## UNITED STATES PATENT AND TRADEMARK OFFICE

APPLICATION NO.	FILING DATE	FIRST NAMED INVENTOR	ATTORNEY DOCKET NO.	CONFIRMATION NO.
10/542,041	02/28/2006	Jean-Pierre Schoellkopf	S1022.81095US00	8689
46329	7590	11/17/2008	EXAMINER	
STMicroelectronics Inc. c/o WOLF, GREENFIELD & SACKS, P.C. 600 Atlantic Avenue BOSTON, MA 02210-2206			CLARK, JASMINE JHIHAN B	
		ART UNIT	PAPER NUMBER	
		2815		
		MAIL DATE		DELIVERY MODE
		11/17/2008		PAPER

<b>Office Action Summary</b>	<b>Application No.</b> 10/542,041	<b>Applicant(s)</b> SCHOELLKOPF, JEAN-PIERRE
	<b>Examiner</b> Jasmine J. Clark	<b>Art Unit</b> 2815

**DETAILED ACTION**

FIG. 11

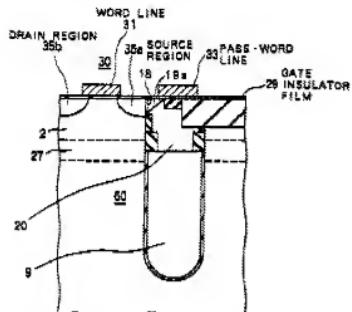
Claims 11 and 12 are rejected under 35 U.S.C. 102(b) as being anticipated by Sudo et al. (US 6,204,527).

Sudo '527 discloses at least one capacitor formed on an IC substrate, the at least one capacitor comprising: a first electrode 35a, for example of MOs transistor, a first capacitor dielectric region 60 having at least a portion that contacts the first electrode 35a and is buried beneath the first electrode; and a second electrode 20 buried beneath the first electrode, the second electrode being insulated from the first electrode, wherein the second electrode is electrically connected to a gate 31 of the MOS transistor.
